# Recall Bulletin

## PRODUCT SAFETY RECALL

**SUBJECT: Rear Suspension Bolts May Not Be To Proper Torque Specification**

**MODELS: 2013 Chevrolet Malibu**

### Fastener Location Overview

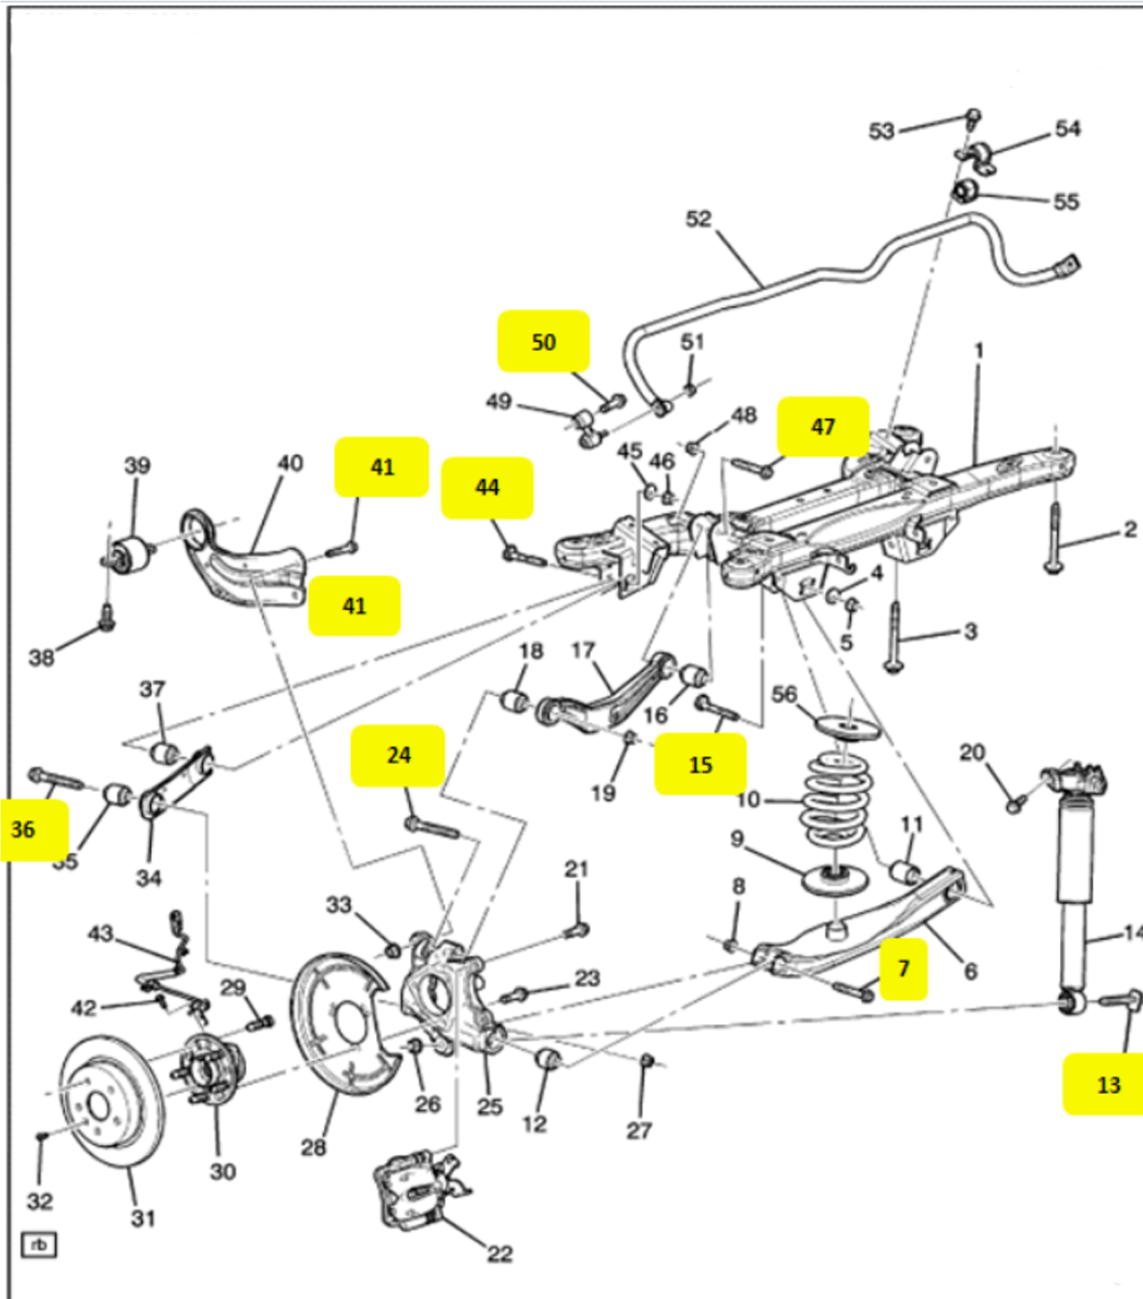
**Part numbers for the rear stab bar shaft link bolt, rear suspension link inner nut, and rear suspension lower control arm inner nut, have been revised in the Part Information Section and in the Static Torque Specification Table and Fastener Replacement Torque Specification Table.**

3. Perform a static torque inspection on the 20 rear suspension fasteners listed in the *Static Torque Specification Table* in this bulletin.
    - Ensure the 20 fasteners meet the minimum static torque specification provided in the table. Refer to the table to determine if torque must be applied to the bolt or nut.

- Replace ALL fasteners that do NOT meet the minimum torque specification with a new fastener. The fastener part number is provided in the *Parts Information* section of the bulletin.

FLO Illustration Number.	Bolt Reuse	Bolt Name	Bolt P/N.	Nut P/N	Static Specification Min (Nm)
13	No	Rear Shock Absorber to Knuckle	<b>11611099</b>		170 Nm
50	Yes	Rear Stab Bar Shaft Link	<b>11518630</b>		50 Nm
44	No	Rear Suspension Link Inner	13219181	<b>11094488</b>	100 Nm
36	No	Rear Suspension Link Outer	<b>11561300</b>		130 Nm
15	No	Rear Suspension Lower Control Arm Inner	13219184	<b>11094488</b>	100 Nm
7	No	Rear Suspension Lower Control Arm Outer	<b>11609607</b>		90 Nm
41	No	Rear Suspension Trailing Arm to Knuckle	<b>11589355</b>		160 Nm
Opposite to 41	No	Rear Suspension Trailing Arm to Knuckle	<b>11589355</b>		160 Nm
47	No	Rear Suspension Upper Control Arm Inner	11589279	<b>11516078</b>	80 Nm
24	No	Rear Suspension Upper Control Arm Outer	<b>11611105</b>		190 Nm

Shaded cells indicate where the torque must be applied: bolt or nut. Always use a backup wrench and calibrated torque wrench to verify torque.
